HINCKLEY NATIONAL RAIL FREIGHT INTERCHANGE

Project reference TR050007

Applicant's response to Deadline 5 Submissions [part 2 - HBBC]

Document reference: 18.19

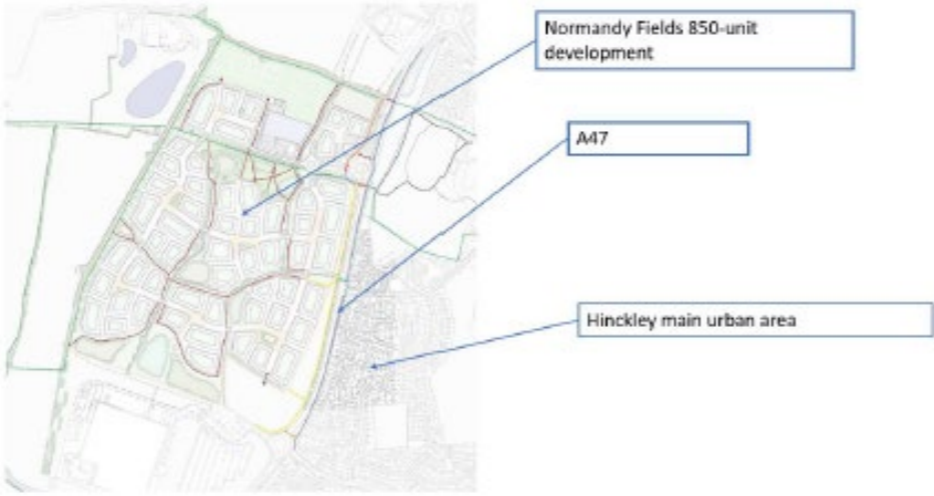
<p>A5/A47/B4666 roundabout junction (and related A5/A47 Longshoot signal junction) and M69 Junction 3 (junction with A5)</p>	<p>The operation of these junctions on the second key strategic route in the borough of the A5 (the M69 above is the other one) remains a significant concern for HBBC – problems here lead to vehicles re-routing through Hinckley. The applicant is proposing no mitigation, and the day-to-day existing conditions here include significant delays and queuing, even outside of the peak hours. If this is exacerbated there will pressure to divert from the strategic network to other local roads with consequent problems. The Google traffic plans below show existing conditions, with congestion also being experienced between the peak hours.</p> <p>The modelling and assessment of these junctions has not yet been accepted by the highway authorities and until this is the case, there is doubt over the conclusions. HBBC notes that at present all site HGVs from the A5 use the A47 to the link road to the site (rather than the A5/M69 route) in the morning peak and representations have been made to designate this route an Undesirable Road in the HGV strategy; this will impact all of the junction assessments along this stretch of the A5.</p> <p>AM peak Typical Google Maps Delays – 2024 existing (Google maps Traffic data)</p>	<p>The Applicant has carried out further surveys and has run the additional VISSIM at the A5 Dodswell/Longshoot, this was submitted at Deadline 4 (document reference REP4-131). The evidence from the PRTM and the VISSIM conclude that the development impacts on these locations are not severe. It is not the Applicant's position to resolve underlying traffic issues but mitigate the impact of additional traffic generated by the development.</p> <p>Contrary to the point raised here, HGVs generated by the site broadly will use J2 M69 to access the SRN. There has been a sensitivity exercise carried out to quantify the high-sided HGVs which would use this route, should the Nutts Lane Bridge carriageway lowering not be implemented (document reference: 18.15.2, REP5-032).</p> <p>It should be noted that Google traffic only indicates typical speeds through a network and does not provide calibrated evidence of capacity and delay.</p>

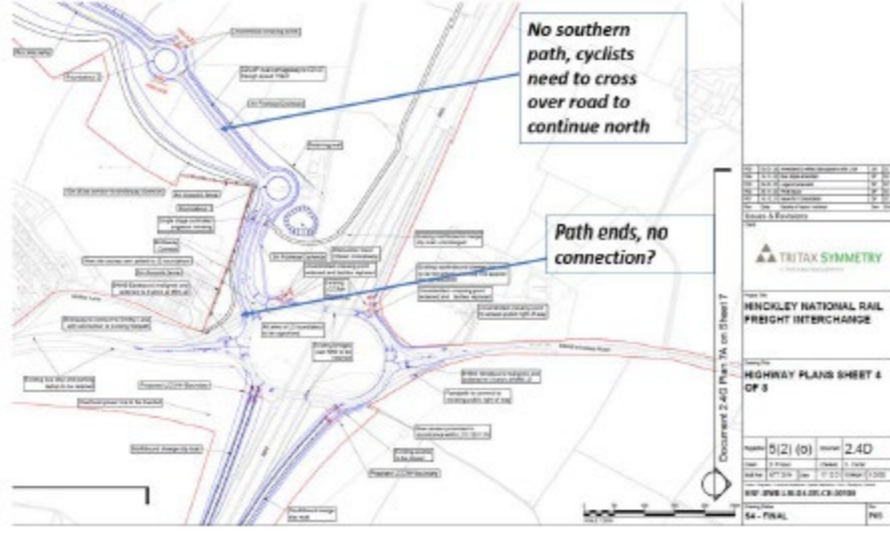
<ul style="list-style-type: none"> There should be a firm commitment to a shuttle service between the site main bus stop and all the premises every 10 minutes during the times the buses are running to the stop. 	<p>There is commitment to provide a shuttle bus on the site connecting with the main bus interchange and the plots. This is set out in paragraph [10.9] of the STS (document reference 6.2.8.1D). The frequency will depend on the linking public services. Ten minutes limits the operation prior to understanding how this works on a practical level.</p>
